APPROVED 13 Apr 50 REVISED ① 17 Nov 54 ② 11 Apr 57 ③ 3 Oct 57 ④ 17 May 57 ⑤ 19 Oct 59

PROCUREMENT SPECIFICATION	AIR FORCE-NAVY AERONAUTICAL STANDARD	AN3304
MIL-R-6106	RELAY, 3 AMP, 4PDT, SEALED, PANEL MOUNTING, CLASS O

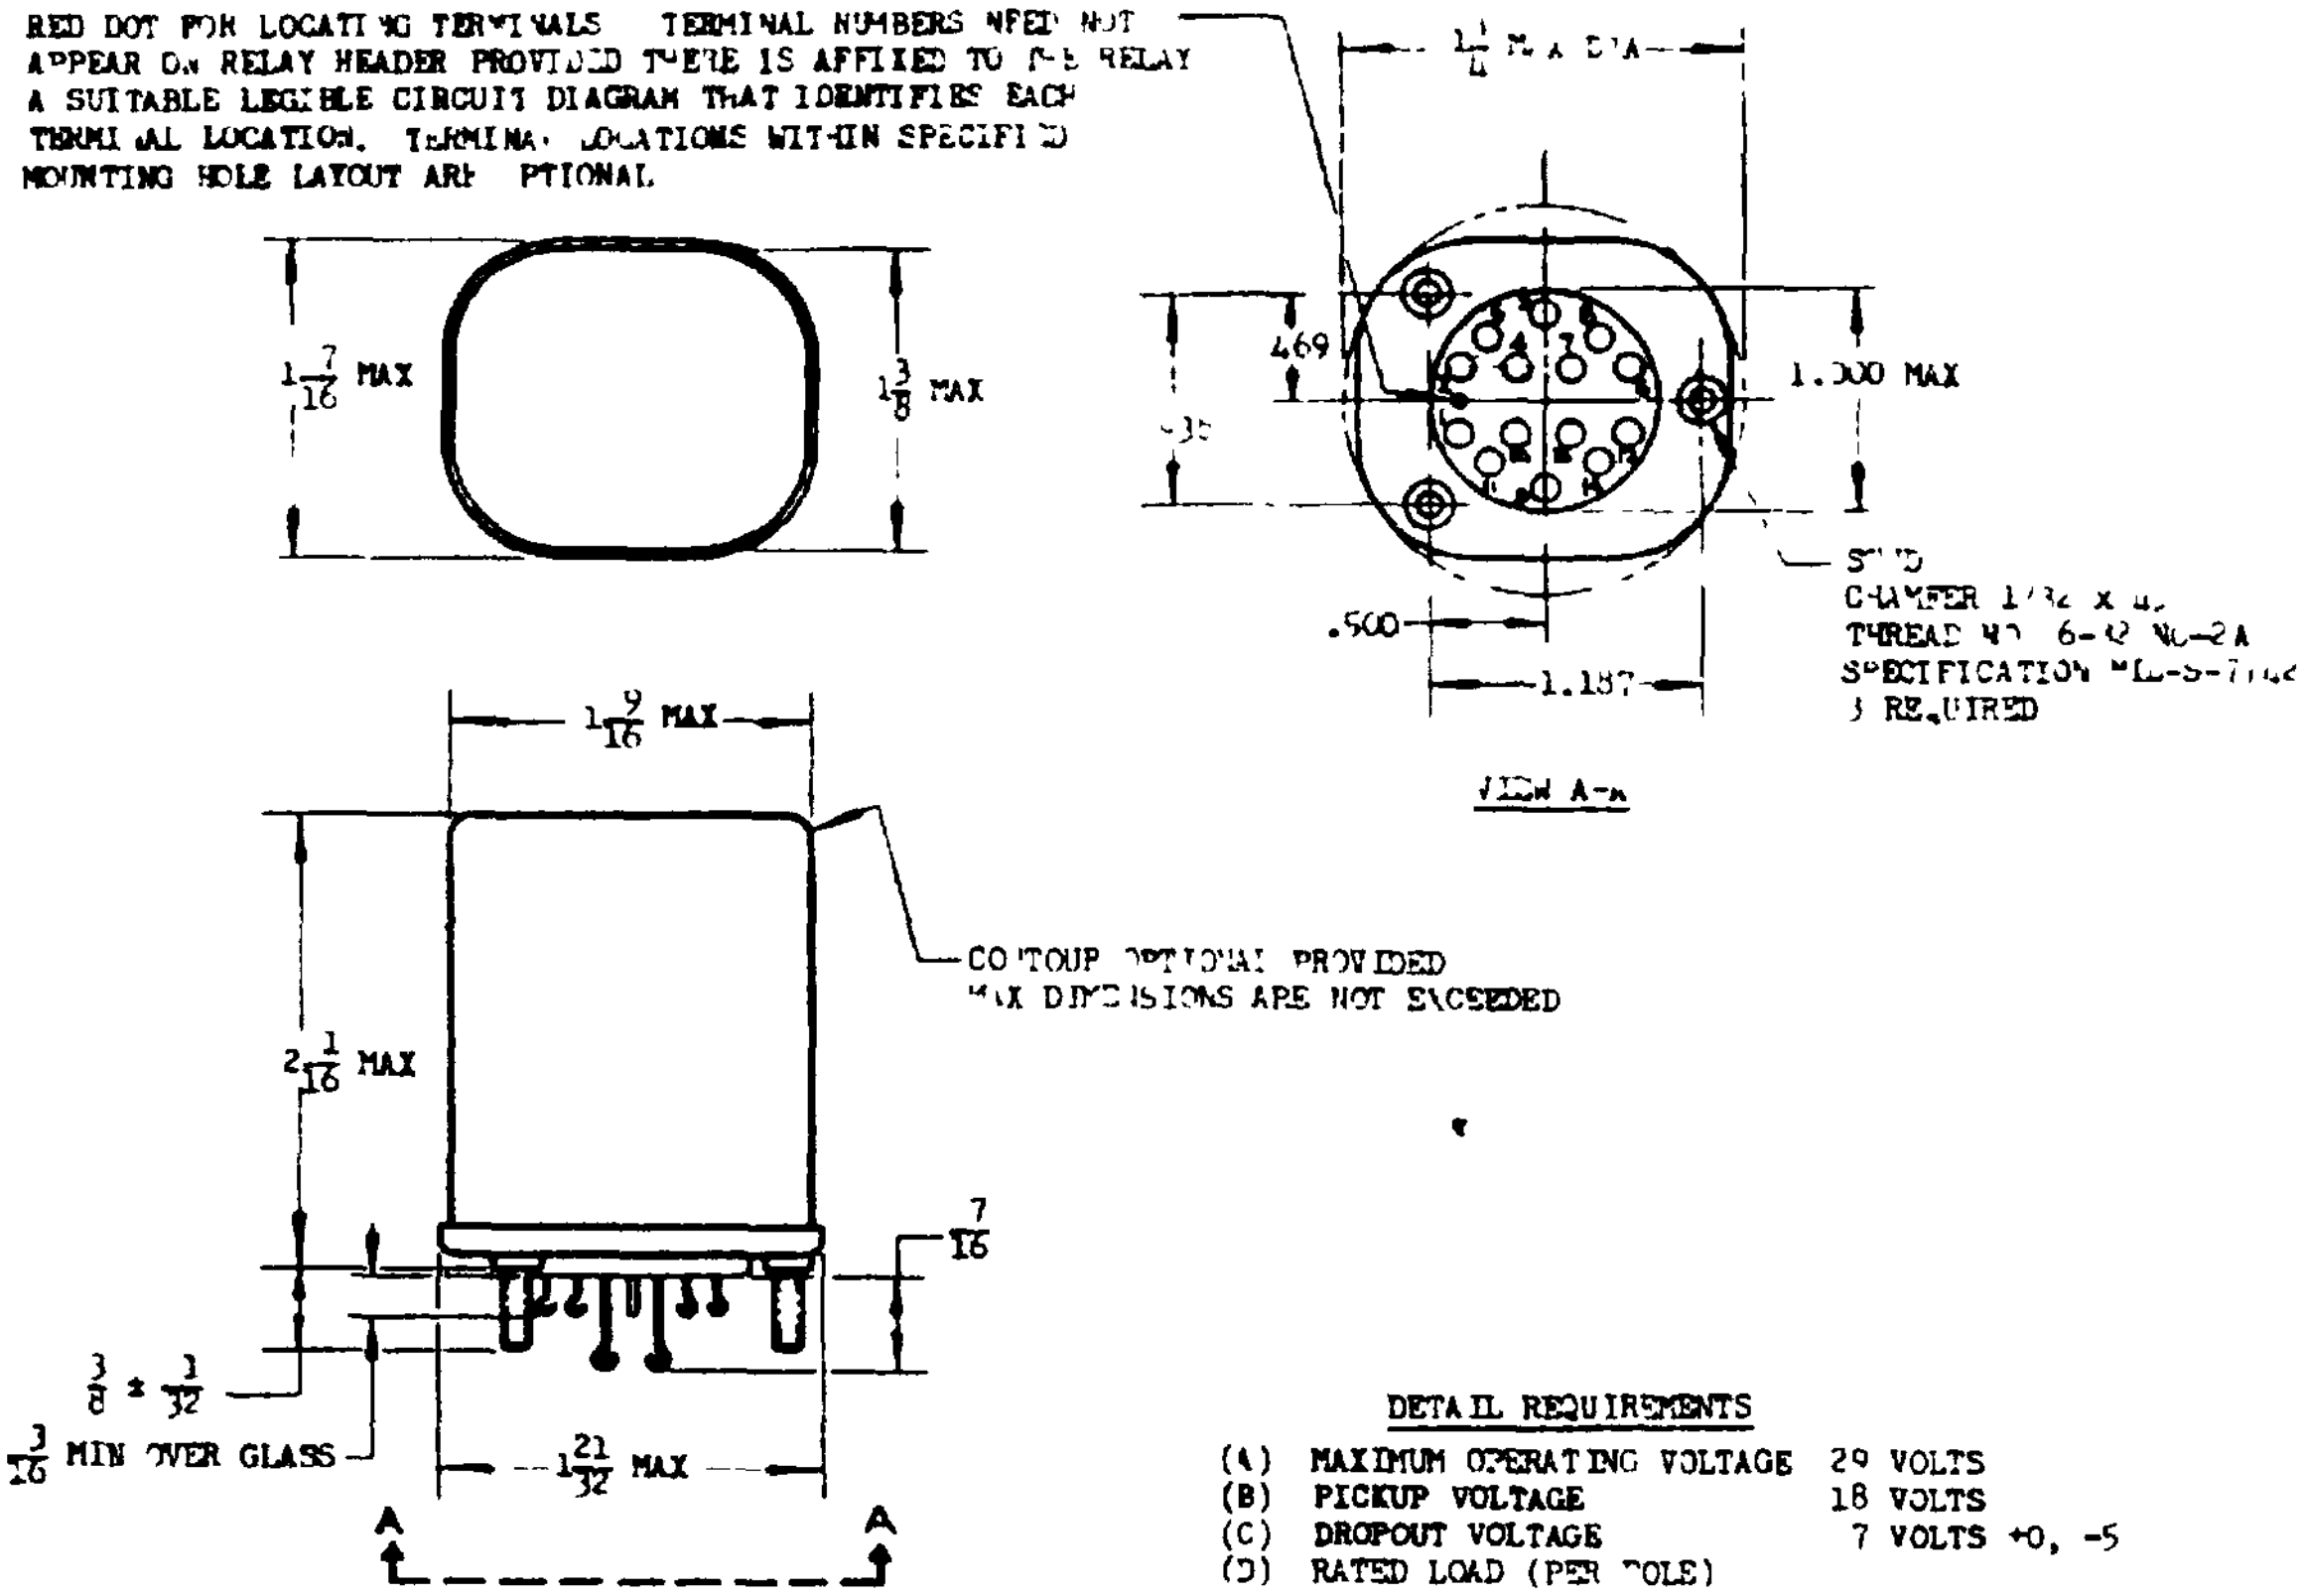
⑤ RED DOT FOR LOCATING TERMINALS. TERMINAL NUMBERS NEED NOT APPEAR ON RELAY HEADER PROVIDED THERE IS AFFIXED TO THE RELAY A SUITABLE LEGIBLE CIRCUIT DIAGRAM THAT IDENTIFIES EACH TERMINAL LOCATION. TERMINAL LOCATIONS WITHIN SPECIFIED MOUNTING HOLE LAYOUT ARE OPTIONAL.

⑤ INACTIVE FOR DESIGN AFTER 19 MAY 1959 USE MS25267

PART NO AN3304-1 INACTIVE FOR DESIGN AFTER 3 OCTOBER 1957 USE PART NO AN3304-2

⑤ WHEN PROCUREMENT IS REQUIRED, USE MIL-R-6106, REVISION B. SUBSEQUENT REVISIONS HAVE NO PROVISIONS FOR CLASS "O" RELAYS

(a) PART NO AN3304-2 SHALL MEET OVERLOAD, RUPTURE, CONTACT DROP, AND MINIMUM CURRENT TESTS OF SPECIFICATION MIL-R-6106.
